Access Compliance Report

Public Rights-of-Way

(Curb Ramps)

Intersection ID: 10037289	Main Street: SARDIS_RD_NORTH	Cross Street: N/A	Location: N
ADA ID: EF6B111349F5	Ramp Type: Perp	Initial Pass/Fail: Fail	Overall Compliance: No
Severity Score: 36.25			
Codes/Mitigation Info/Possible Solution		Field Measurements/Component Compliance

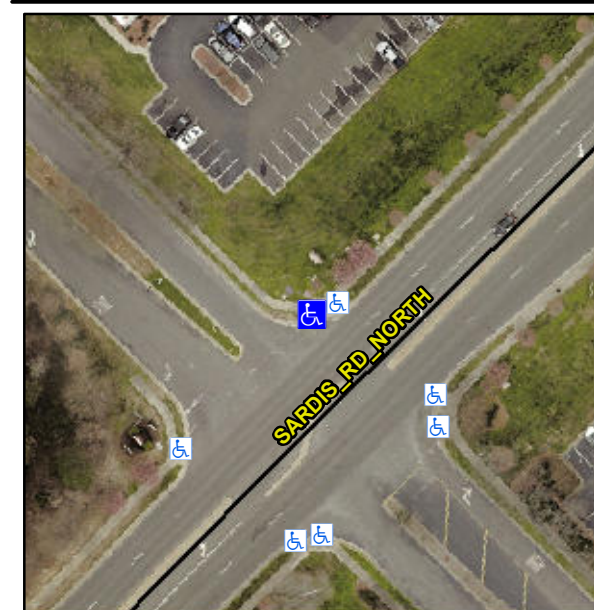
R304.5.1, R304.2.2, R302.7

Compliance	Description	Data	Compliance	Description	Data
N/A	Ramp Length (in)	70.0	No	Ramp Slope (%)	10.2
No	Ramp Width (in)	44.0	Yes	Ramp XSlope (%)	1.4
N/A	Flare Type LT	N/A	N/A	Flare Type RT	N/A
N/A	Flare Slope LT (%)	N/A	N/A	Flare Slope RT (%)	N/A
N/A	Flare Traversable LT?	N/A	N/A	Flare Traversable RT?	N/A
N/A	Landing Length (in)	N/A	N/A	DWS Provided?	N/A
N/A	Landing Width (in)	N/A	N/A	DWS Contrast?	N/A
N/A	Landing Slope (%)	N/A	N/A	DWS Length (in)	N/A
N/A	Landing X Slope (%)	N/A	N/A	DWS Full Width?	N/A
N/A	Landing Curb? (Y/N)	N/A	N/A	DWS Offset (in)	N/A
N/A	Shared Landing?	N/A			
N/A	Gutter Ponding?	N/A	N/A	Gutter Slope (%)	N/A
N/A	Gutter Lip Ht (in)	0.5	N/A	Gutter X Slope (%)	N/A
N/A	Painted X Walk1?	No	N/A	Painted X Walk2?	N/A
	X Walk 1 Direction	To SW		X Walk 2 Direction	N/A
N/A	X Walk 1 Width (in)	N/A	N/A	X Walk 2 Width (in)	N/A
	X Walk 1 Slope (%)	0.5		X Walk 2 Slope (%)	N/A
	X Walk 1 X Slope (%)	2.2		X Walk 2 X Slope (%)	N/A

N/A	Ramp inside XWalk1?	N/A	N/A	Ramp inside XWalk2?	N/A
	Road Slope (%)	N/A	N/A	Clear Space?	N/A
	Road X Slope (%)	N/A	N/A	Clear Space to XWalk (in)	N/A
N/A	Any Obstructions?	N/A	N/A	Storm Grate/Utility Hazard?	N/A
	Obstruction Type			Storm Grate/Utility Type	
		N/A			N/A
		No		Surface Condition? (G/P)	Poor

Remove & Replace Entire Ramp.
